REQUEST: CONVERT EXISTING 6,600 G.P.Y. Date Complete: _____
WINERY INTO A NEW 28,000 G.P.Y. WINERY IN AN ENTIRELY NEW
PRODUCTION FACILITY W/CAVES. ROAD & STREET EXCEPTION & L.L.A
ALSO REQUESTED.

PROJECT NAME: CONTINUUM WINERY

RE: Continuum Winery
Use Permit Major Modification Application Response to Comments
Application No. P10-00255

CAREVAN SERAI WINERY
 NAPA COUNTY
 GRADING AND EROSION CONTROL PLAN

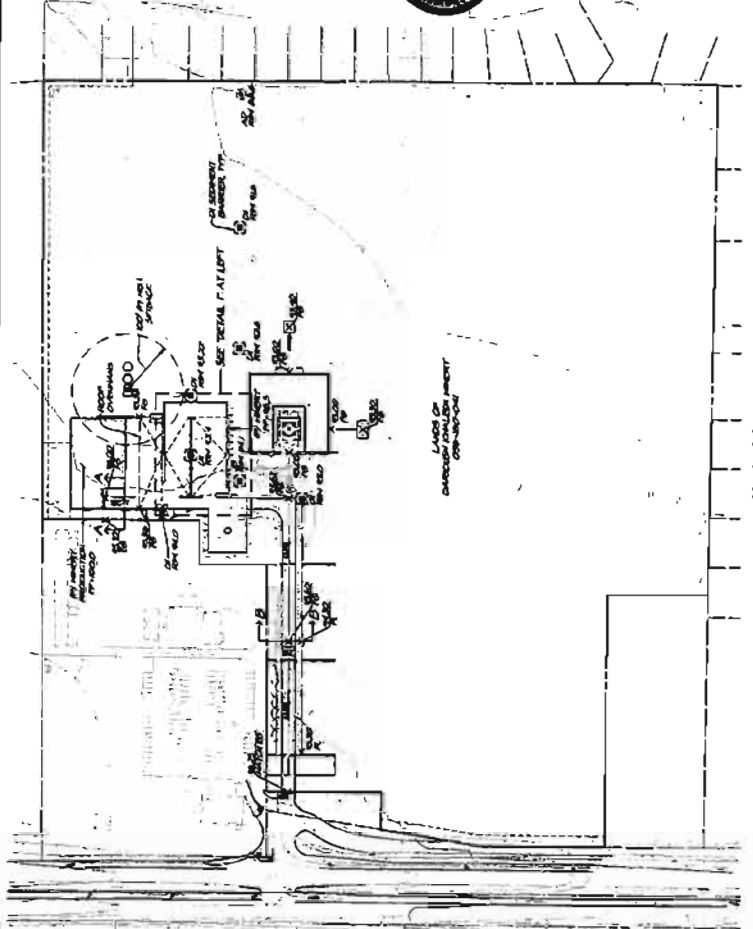
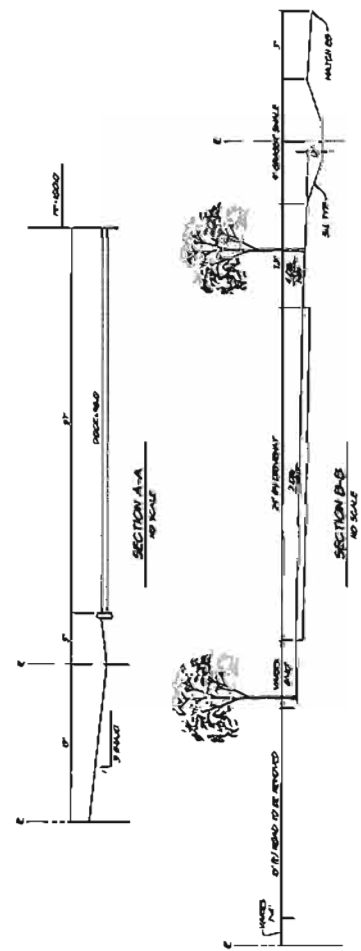
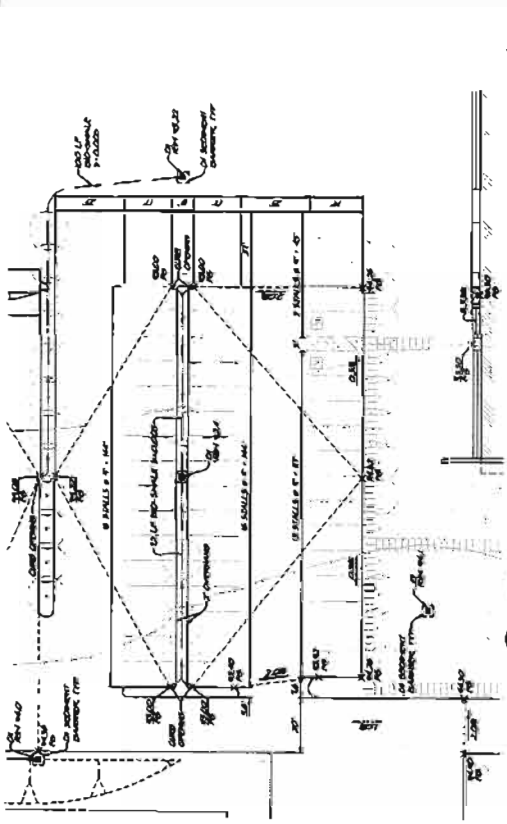
Comment 2: Please submit a site plan depicting proposed temporary cave grading spoils stockpile locations.

- i. Between station 48+00 and 49+00 of the proposed driveway the shoulder is labeled as 35 ft and then shortly after station 49+00 the shoulder is listed as 5ft. This is an area of roadway where an exception to the Napa County Road and Street Standards is requested. Please provide clarification.*
- ii. Note that the parking area just past the mechanical pump building as proposed on the plans will need to meet the requirements listed in the Napa County Road and Street Standards. As shown the parking lot should accommodate a distance of 45' in figure P-1 and page 51 of the Napa County Road and Street Standards.*

This is a typo on the plan. Where it says 35ft it should say 5 ft. This has been corrected on the resubmitted plans.

Parking areas will meet the 45' front to back requirement. The area behind the parking has been expanded to 25 feet.

Response 2: The temporary stockpile is shown on the revised grading plan in the Civil MM plan set. The stockpile will be located at the proposed winery building pad. The cave will be completely constructed prior to the winery construction providing a suitable stockpile location.

Response 2b: These items have been incorporated into the revised Civil MM plans.

- i. Label corrected*
- ii. The area behind the parking is expanded to 25 feet.*
